Reference test fixture S-parameters

(in support of comment R2-100 against D3.2)

Adee Ran, Cisco

HCB model fit to reference

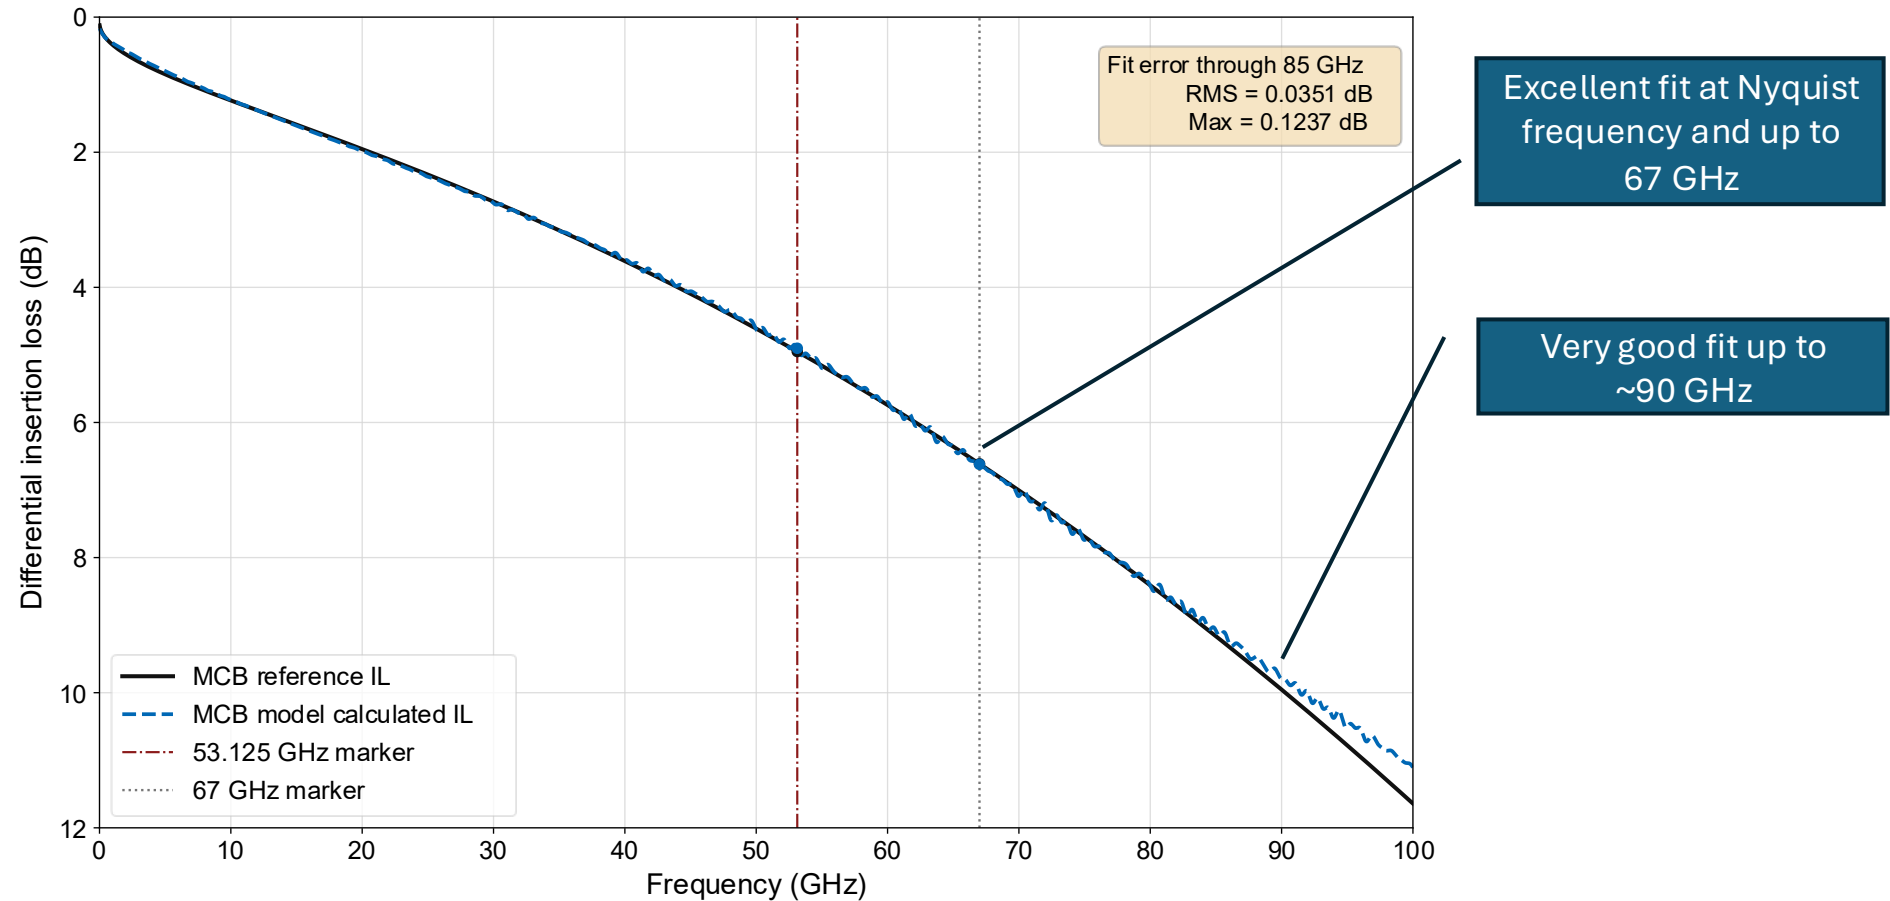
Excellent fit at Nyquist frequency

Very good fit up to 67 GHz, the upper limit for MTF specifications
